Docket Number:	23-OPT-01
Project Title:	Fountain Wind Project
TN #:	253513
Document Title:	Joseph Osa Comments - General Scoping Comments and Areas of Concern
Description:	N/A
Filer:	System
Organization:	Joseph Osa
Submitter Role:	Public
Submission Date:	12/4/2023 2:19:29 PM
Docketed Date:	12/4/2023

General Scoping Comments and Areas of Concern

Subj: General Scoping Comments and Areas of Concern for the Fountain Wind Project

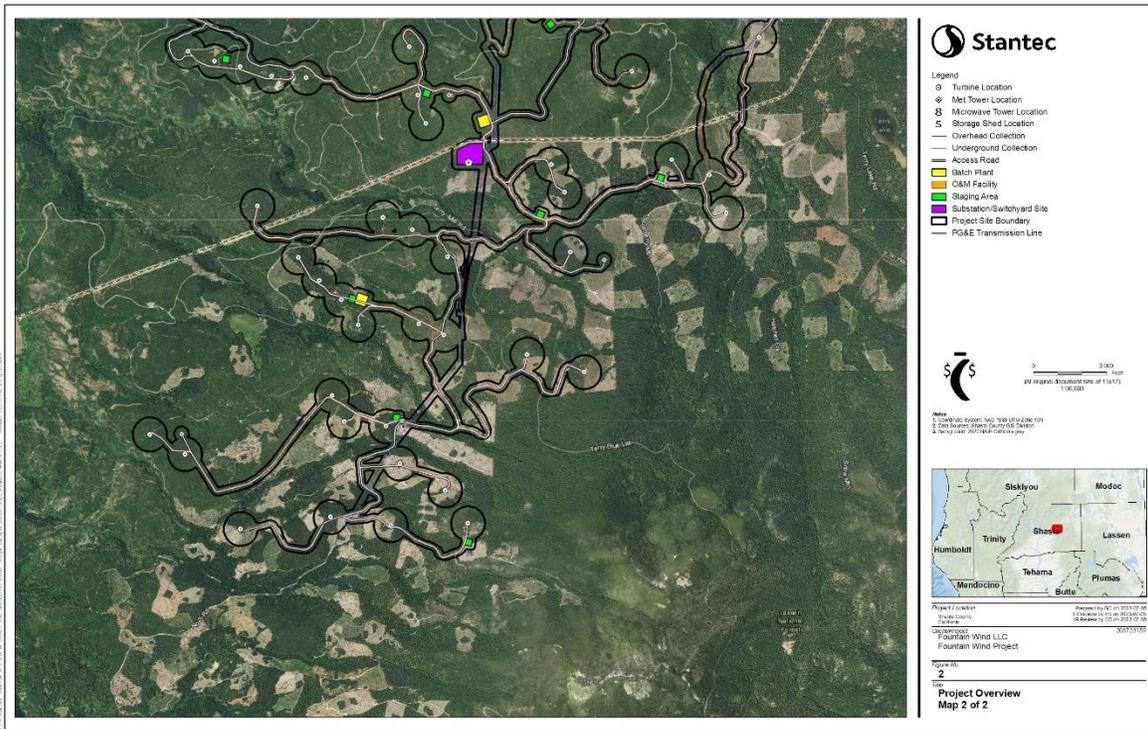
Further effects of turbine wake, in addition to the previously docketed discussion of wake impacts to the power generation of the nearby Hatchet Wind Development, is that of self-interference. It is obvious from the suggested turbine laydown provided by the applicant, as shown below, that there is likely to be multiple cases of self-interference.

Unlike the Hatchet Ridge project where all the turbines are facing the prevailing winds without any of them being downwind of another, the Fountain Wind laydown has many turbines placed such that some are close enough to be impacted by the wake effect with possible further interference in the induction zone forward of the turbines, in the direction of the wind. Ref (B) indicates that wind speeds at turbine hub height can be reduced by 50% or more at 3 turbine rotor diameters (1600 ft) and still reduced by up to 5% at 5 rotor diameters and beyond (2700 ft plus) downwind due to the wake effect and energy extraction and this effect was noted for significantly smaller turbines of only 2.5 MW. Even upwind, in the induction zone, there is significant wind speed reduction up to 3 rotor diameters (1600 ft) away although without much of the turbulence seen downwind in the wake. Any reduction in windspeed will cause a significant reduction in power output because of the power curve and the cubic relationship

The co-interference effect should be modeled for all proposed configurations to determine a more accurate capacity factor so that the overall efficiency of this

North Valley Area – Results (cont'd)

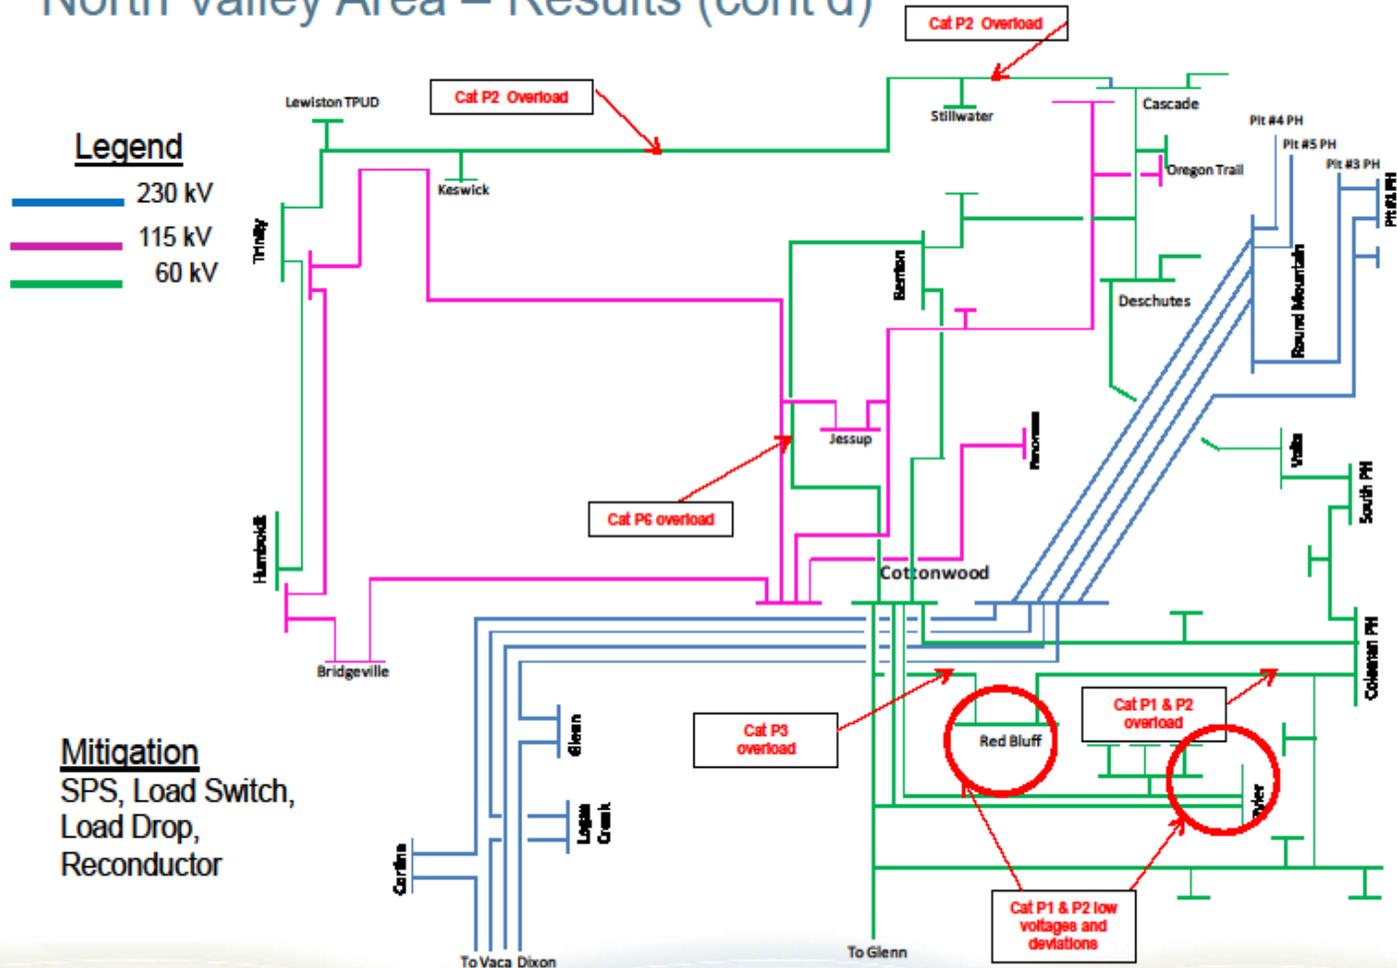
The more recent 2020-2021 Transmission Plan has also identified reliability issues and needed upgrades required to the Cottonwood/Round Mountain 230kV bus as follows:

...Cottonwood 230 kV bus overloads the underlying 115 kV and 60 kV network connected to the Cottonwood substation under the peak load scenario in the near term.

...Round Mountain 230 kV bus overloads the Round Mountain – Cottonwood 230 kV Line under the peak load scenario in the near term.

The CAISO is recommending protection upgrades at Cottonwood 230 kV and Round Mountain 230 kV substations to address overload under P5-5 contingency.
